APPLICATION NO.	FILING DATE	FIRST NAMED INVENTOR	ATTORNEY DOCKET NO.	CONFIRMATION NO.
10/820,080	04/06/2004	Paul Ciccone	SYNT-0237	7100
53443	7590	12/28/2007	EXAMINER	
WOODCOCK WASHBURN LLP			RAMANA, ANURADHA	
CIRA CENTRE, 12TH FLOOR			ART UNIT	
2929 ARCH STREET			PAPER NUMBER	
PHILADELPHIA, PA 19104-2891			3733

Office Action Summary	Application No.	Applicant(s)
	10/820,080	CICCONE ET AL. <i>CT</i>
	Examiner Anu Ramana	Art Unit 3733

DETAILED ACTION

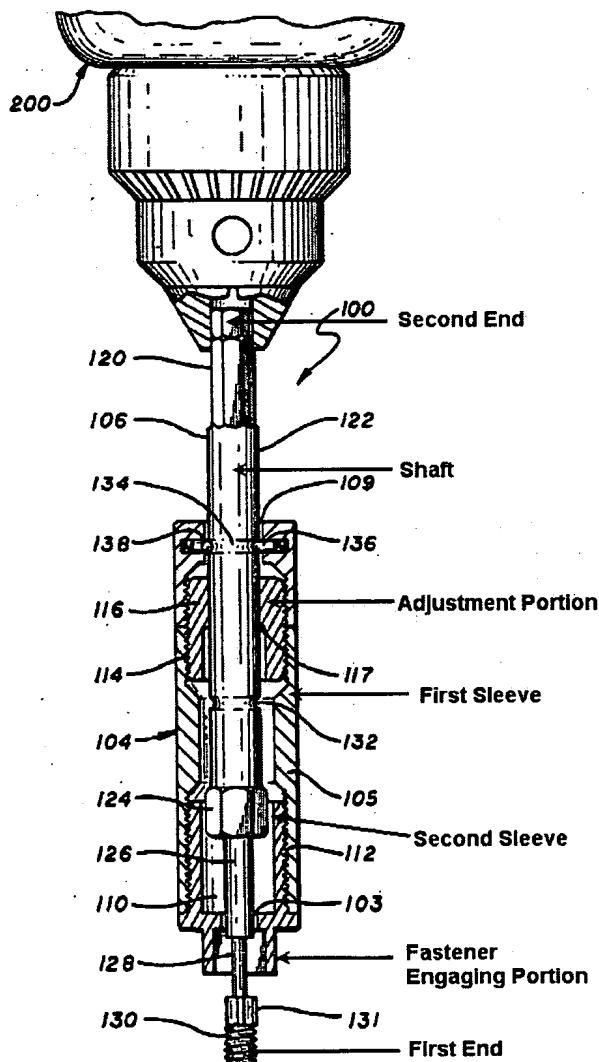
Lemke et al. disclose an adjustable tool including: a shaft (122, 116) with calibration markings (132, 134); a cutting portion 130, i.e. a portion capable of cutting

into material; a fastener engaging portion 102; an adjustment portion 116; and an adjustment mechanism including a first sleeve 105 and a second sleeve 112 mounted on the shaft wherein the cutting portion and the fastener engaging portion can be rotated at different speeds with respect to one another (Figs. 4 and 5, col. 6, lines 47-68, col. 7 and col. 8, lines 1-2). See marked up Fig. 5 from Lemke et al. below.

Claims 1 and 38 recite a "shaft comprising an adjustment portion that is externally threaded." It is the Examiner's position that Applicants' claimed invention is anticipated by Lemke et al. since the claim does not require the adjustment portion to be monolithically formed with the shaft. Lemke et al. clearly show a shaft 122 having an adjustment portion 116.
